August 2025
Design Development Updates

Upper Brook Street Masterplan (McLaren / Kadans)

UBS-SRA-XX-XX-RP-A-00101

This document has been produced by Sheppard Robson and proposes minor changes to the approved Sci-Tech scheme located in Upper Brook Street, Manchester.

Sixth Floor
Consented Plan

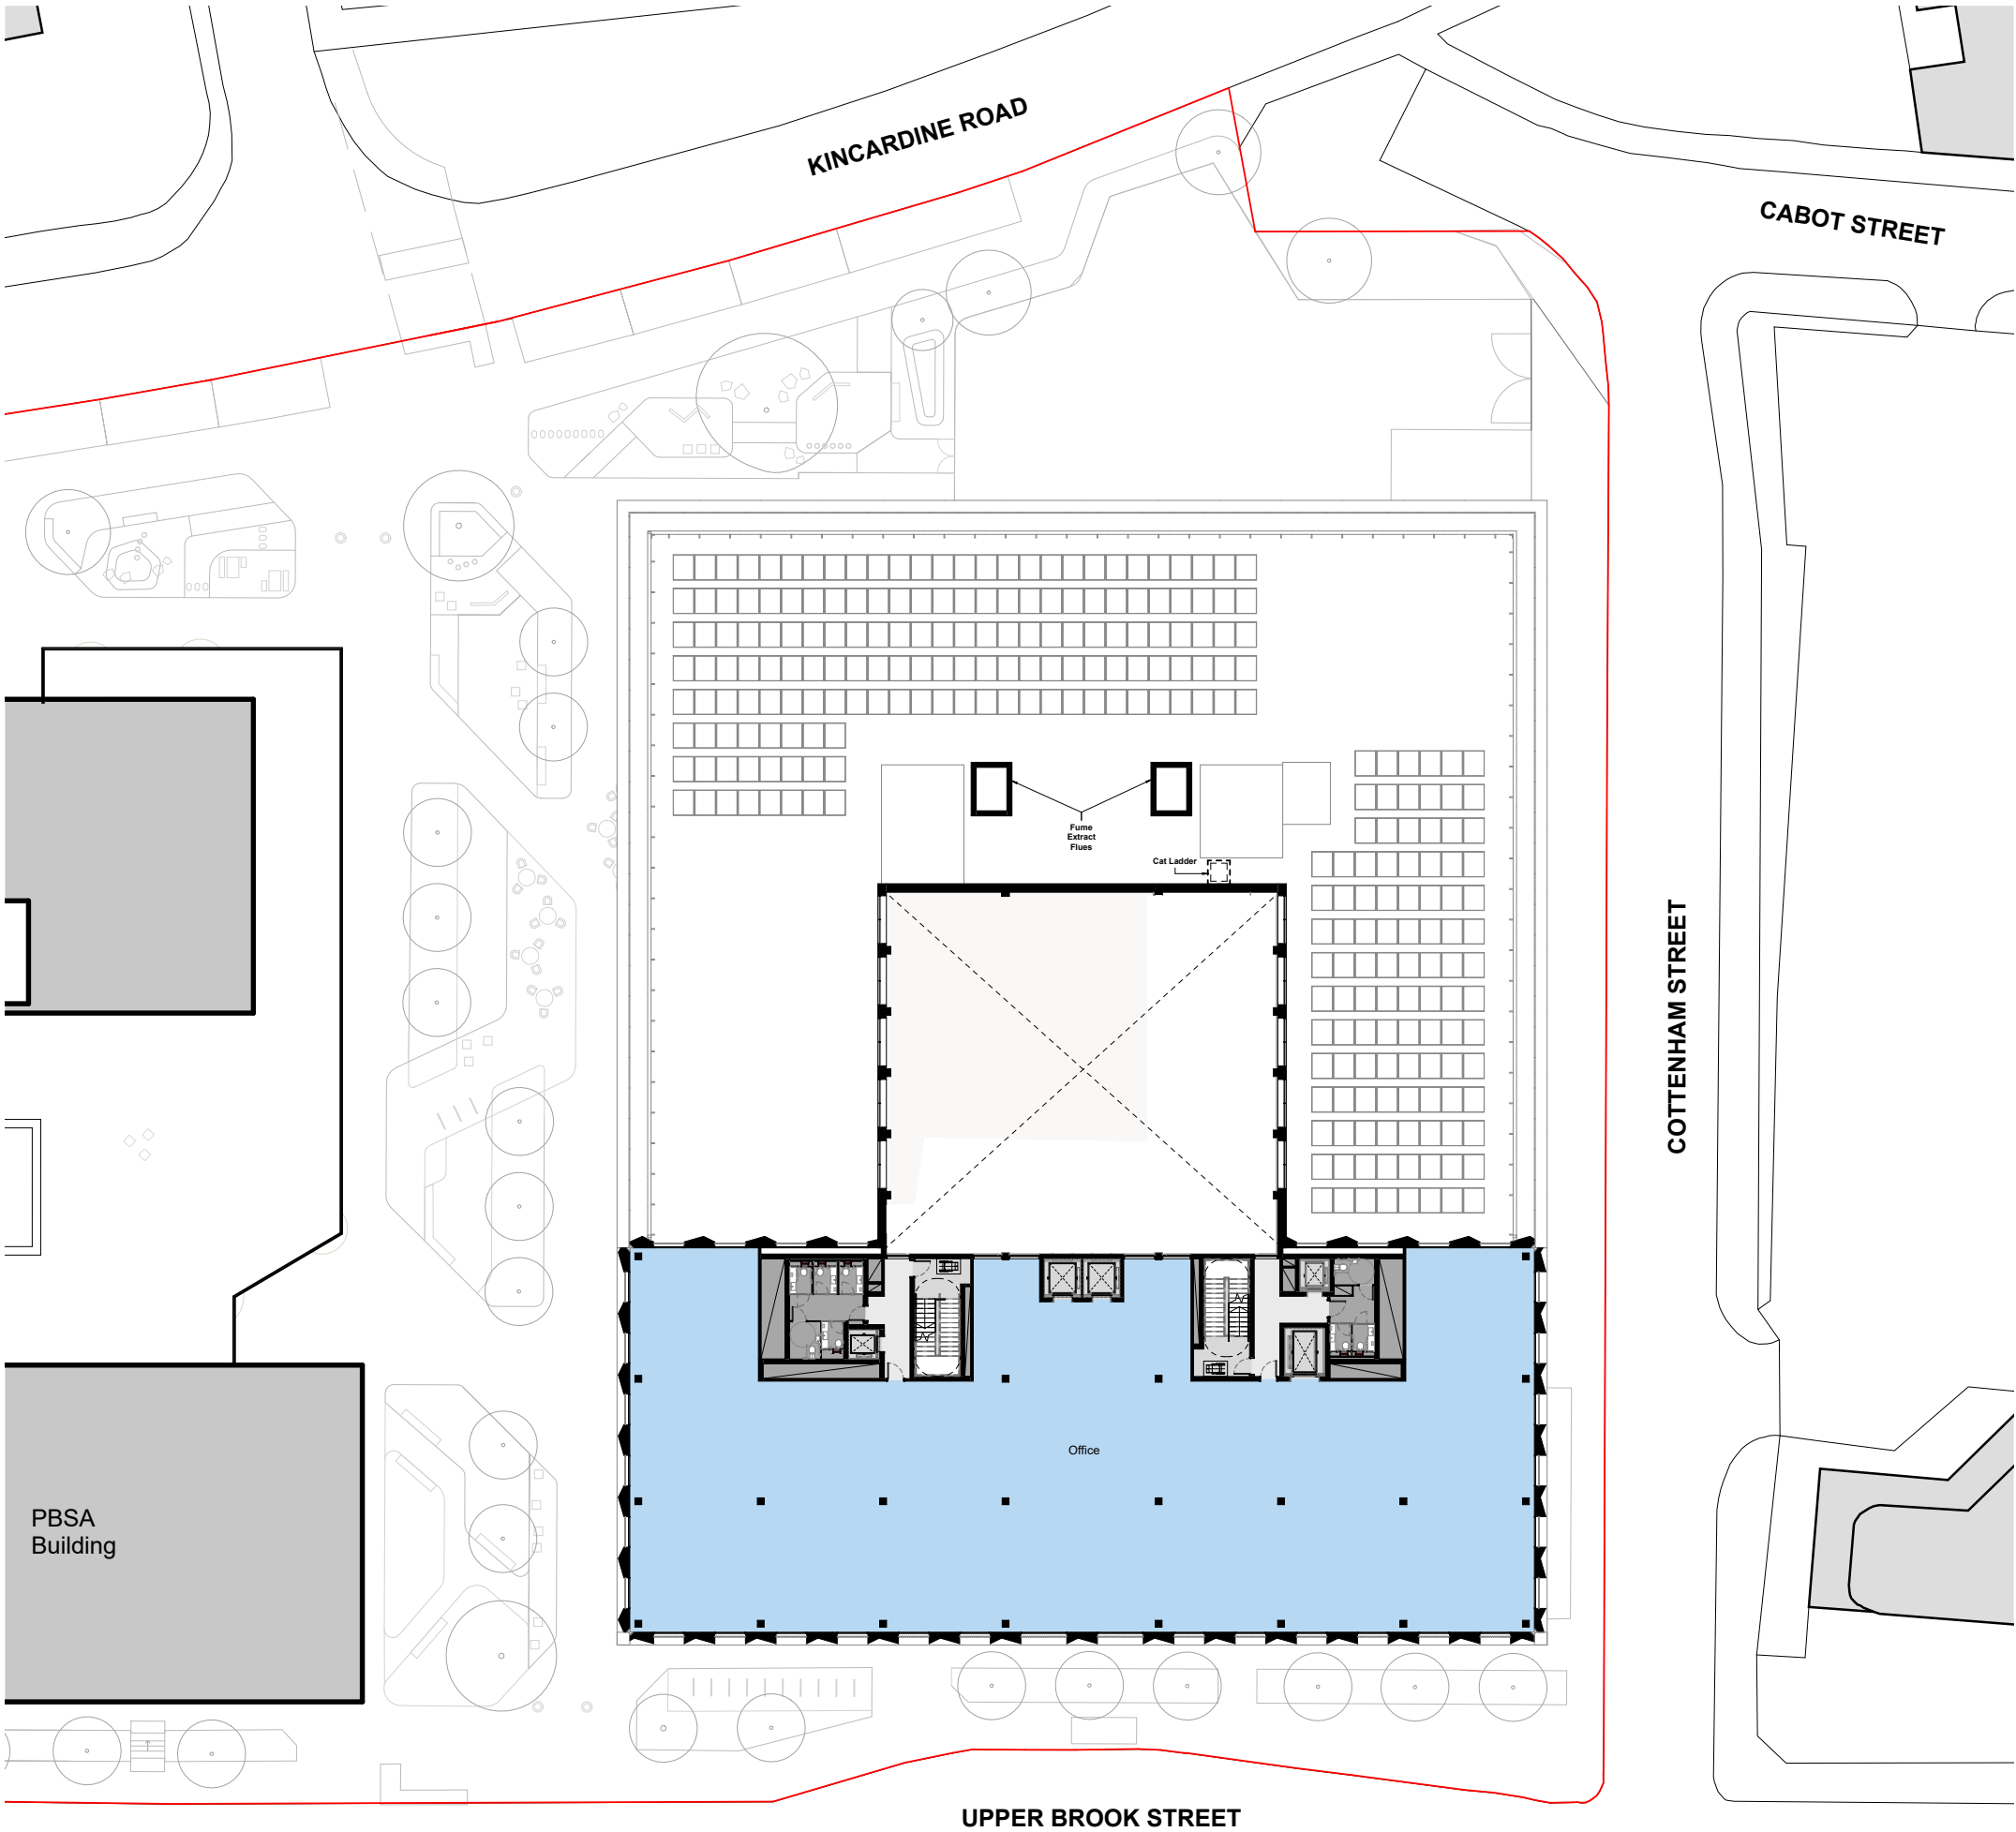
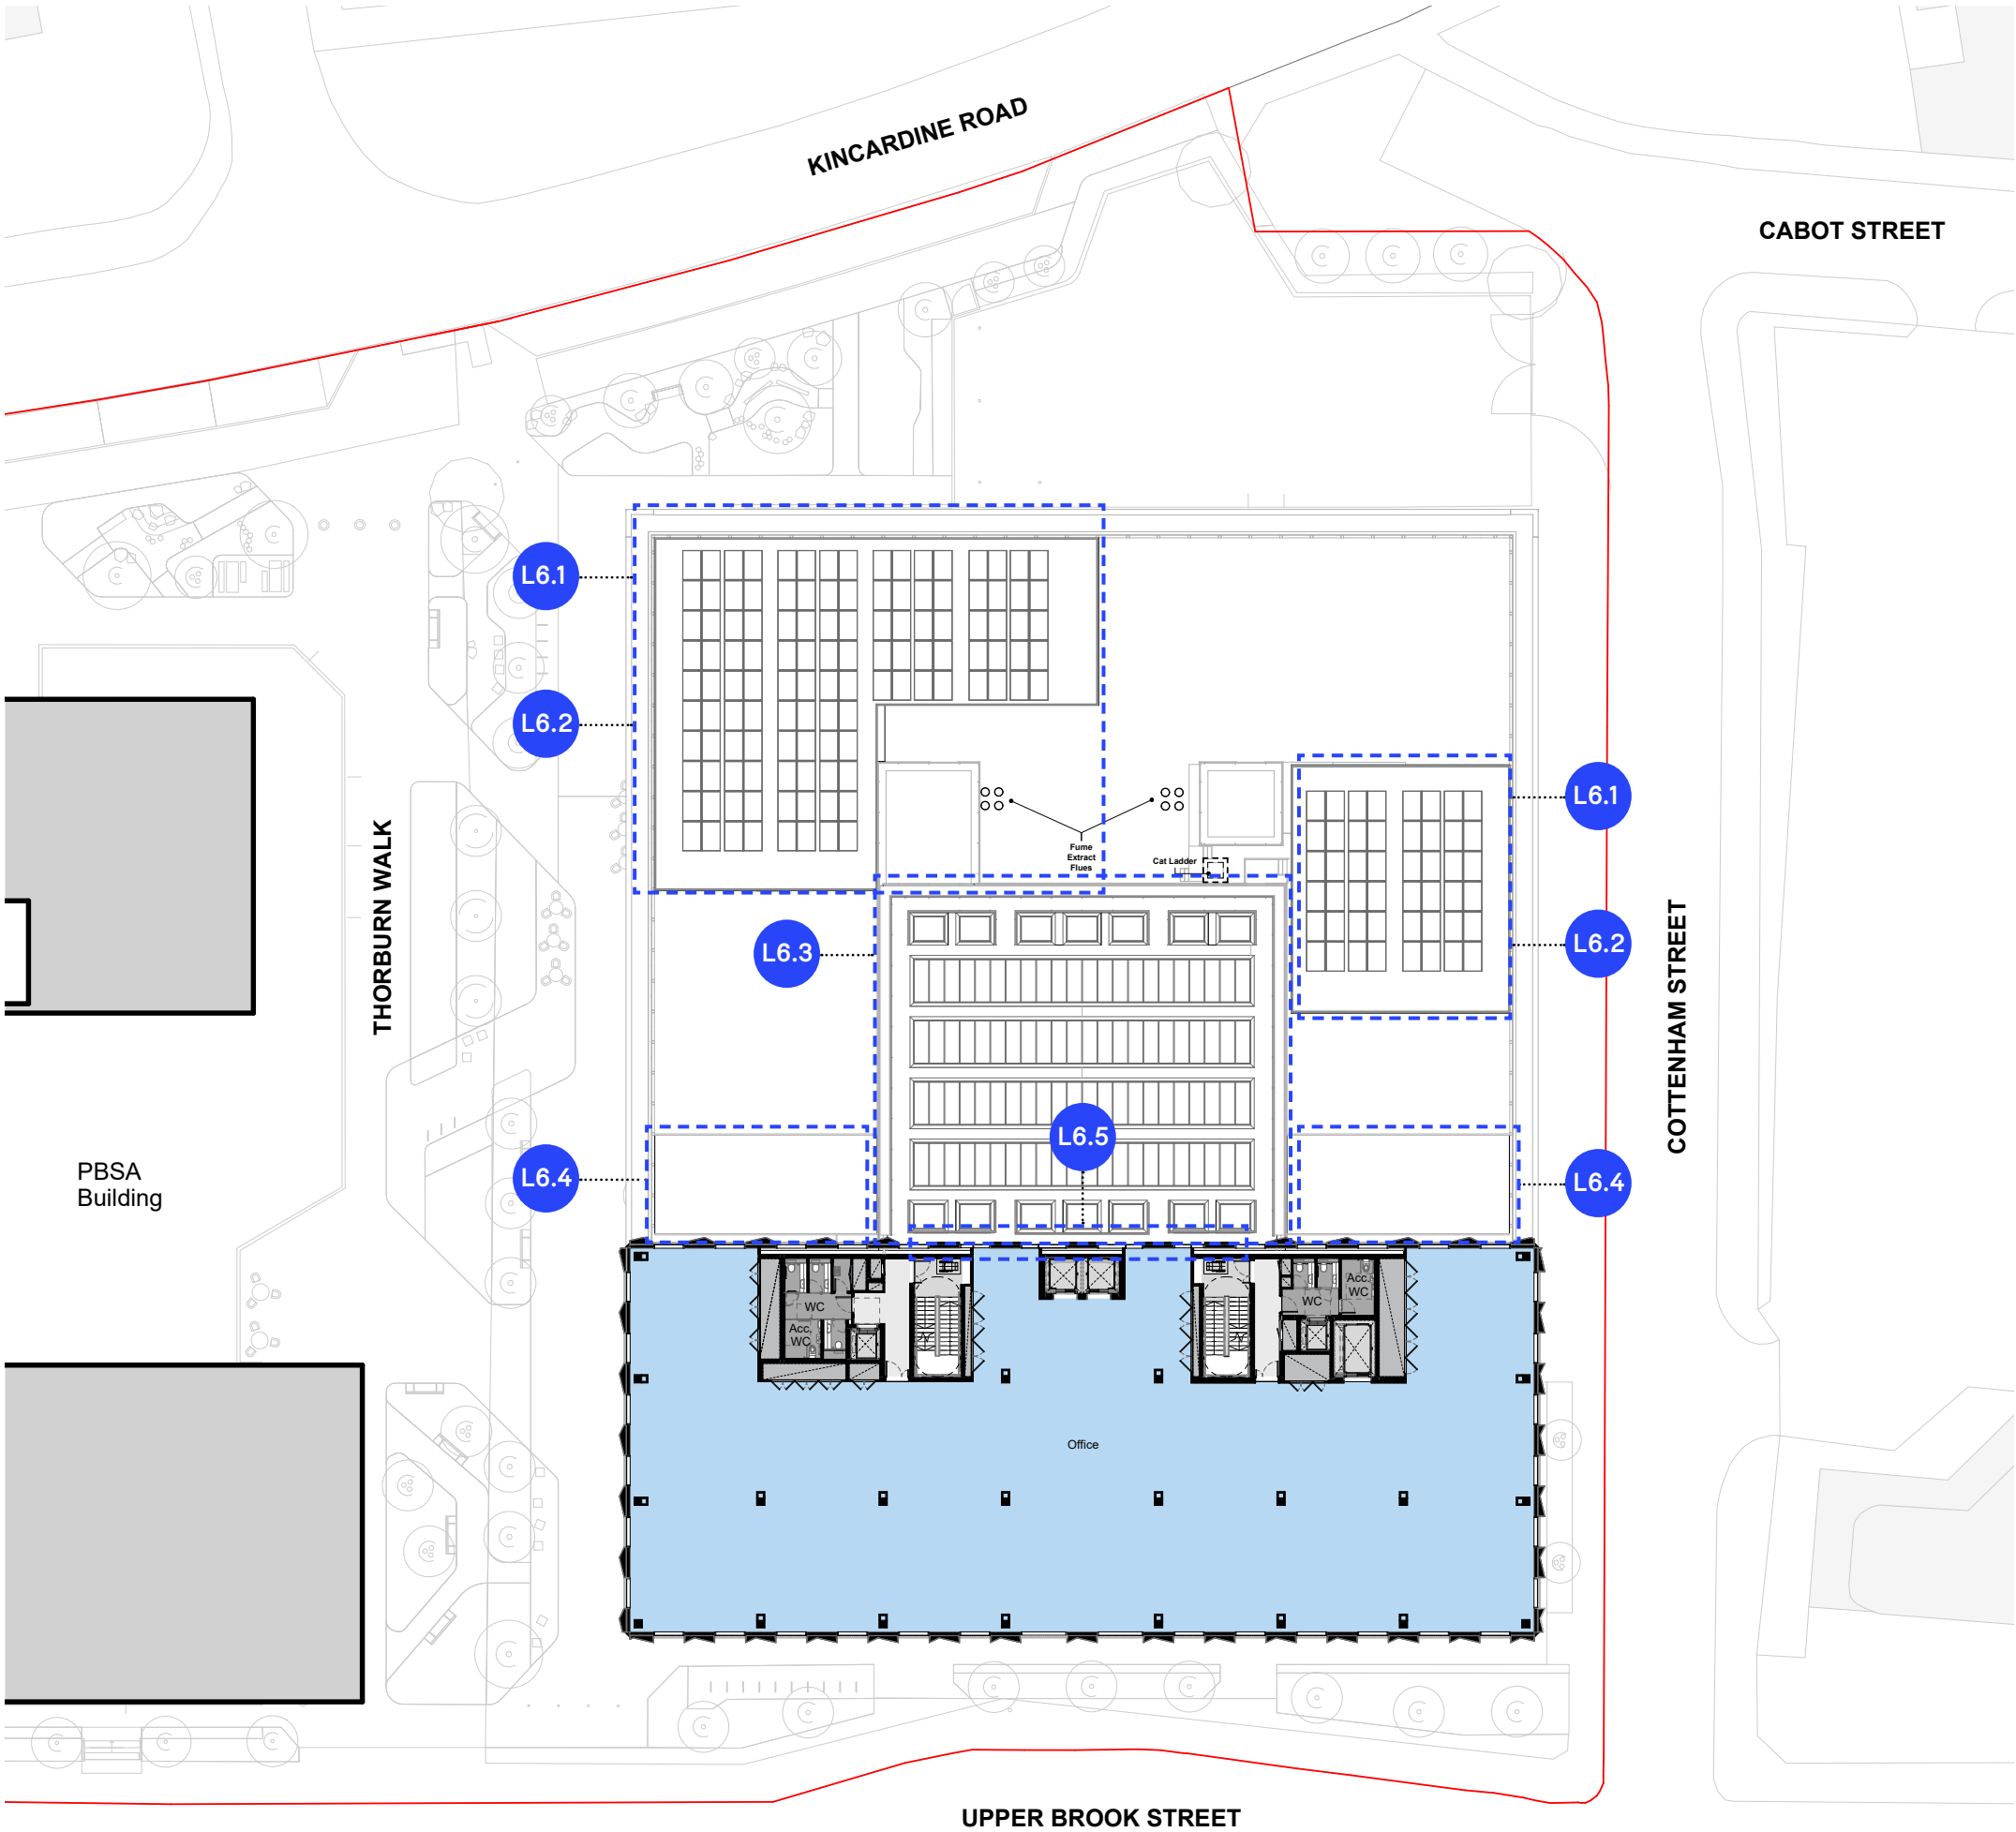
- L6.1** The PV layout and the platform extent was optimised.
- L6.2** A safety perimeter guardrail was added to the PV platforms.
- L6.3** The Atrium roof was lowered one level, from Level 07 to Level 06. Changes to the Atrium roof design.
- L6.4** Two additional platforms have been added to comply with the A&M strategy.
- L6.5** The piers directly above the atrium roof are to be flattened to allow for the minimum maintenance clearance.

Change Code	Drawings Affected	Description	Design Development Justification
L6.1, L6.2, L6.3	• UBS-SRA-ST-05-DR-A-02-506 to 509 • UBS-SRA-ZZ-ZZ-DR-A-02-103* • UBS-SRA-ZZ-ZZ-DR-A-02-104* • UBS-SRA-ZZ-SE-DR-A-02-320 • UBS-SRA-ZZ-SE-DR-A-02-322 • UBS-SRA-ZZ-EN-DR-A-02-306 • UBS-SRA-ZZ-EW-DR-A-02-308 • UBS-SRA-ZZ-EW-DR-A-02-311	• PV Layout and platform rearranged. Safety perimeter guardrail added. • The Atrium roof was lowered by one level with changes to the Atrium roof design.	• PV Layout arrangement and platform design updated following MEP design development. A safety guardrail has been added around the PV platform for health and safety reasons following access and maintenance specialist advice. • The atrium roof was lowered and developed through a series of workshops with specialists
L6.4	• UBS-SRA-ST-05-DR-A-02-506 to 509 • UBS-SRA-ZZ-ZZ-DR-A-02-103* • UBS-SRA-ZZ-ZZ-DR-A-02-104* • UBS-SRA-ZZ-SE-DR-A-02-320	• Additional platforms added to comply with the A&M strategy.	• The strategy was developed following a series of workshops with facade and A&M specialists

L6.5	• UBS-SRA-ST-05-DR-A-02-506 • UBS-SRA-ZZ-EN-DR-A-02-306 • UBS-SRA-ZZ-SE-DR-A-02-320 • UBS-SRA-ZZ-SE-DR-A-02-322	• Facade piers directly above the atrium roof flattened	• This change has been developed to allow for the minimum maintenance clearance to the AOVs.

Atrium Roof Design

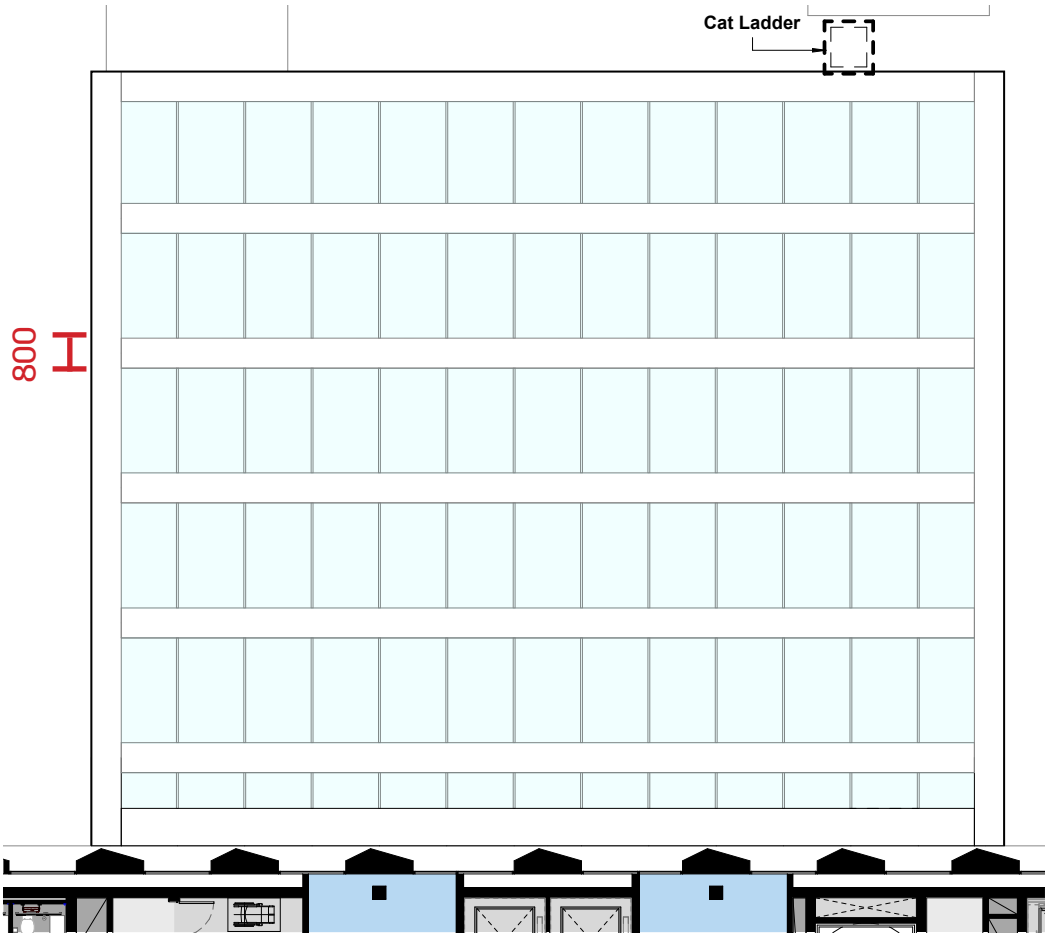
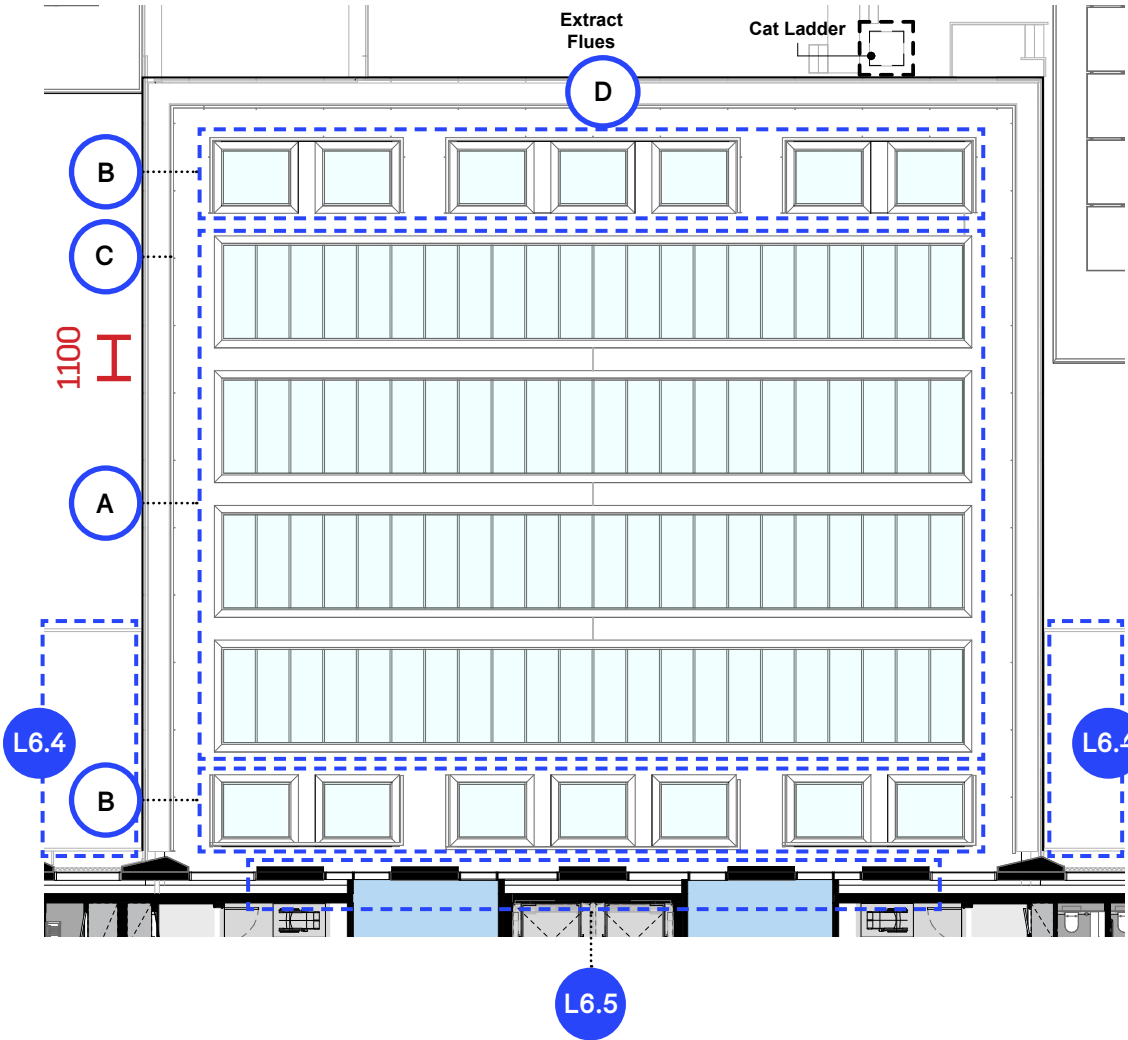
- L6.3** The Atrium roof was lowered one level, from Level 07 to Level 06. Changes to the Atrium roof design:
- A** The atrium roof lights have been rationalised.
- B** AOVs relocated to comply with the fire strategy
- C** A safety rail has been included around the atrium
- D** The roof design has developed into flat roof, from sloped roof in the consented scheme
- L6.4** Two additional platforms have been added to comply with the A&M strategy.
- L6.5** The piers directly above the atrium roof are to be flattened to allow for the minimum maintenance clearance.

Arkley Street View

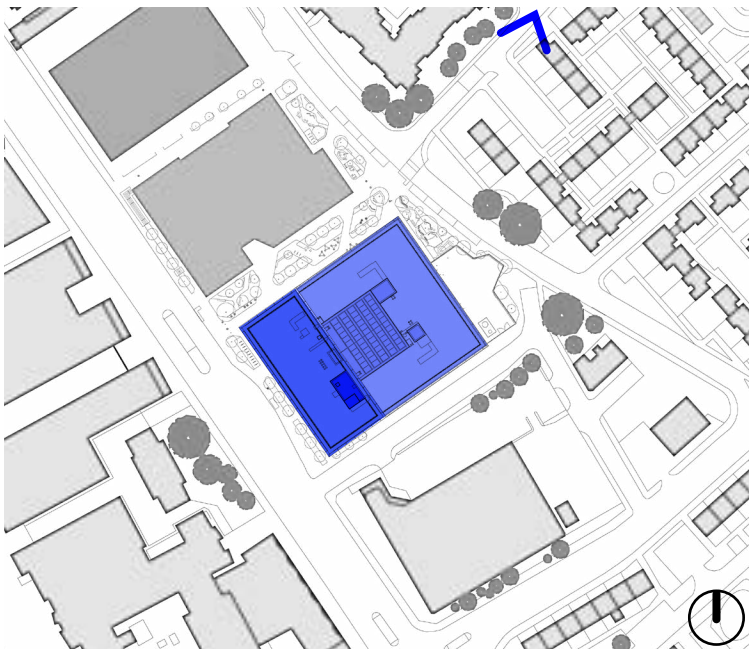
- L6.2** A safety perimeter guardrail was added to the PV platforms.
- L6.3** The Atrium roof was lowered one level, from Level 07 to Level 06.
- L6.4** Two additional platforms have been added to comply with the A&M strategy.
- L6.5** The piers directly above the atrium roof are to be flattened to allow for the minimum maintenance clearance.
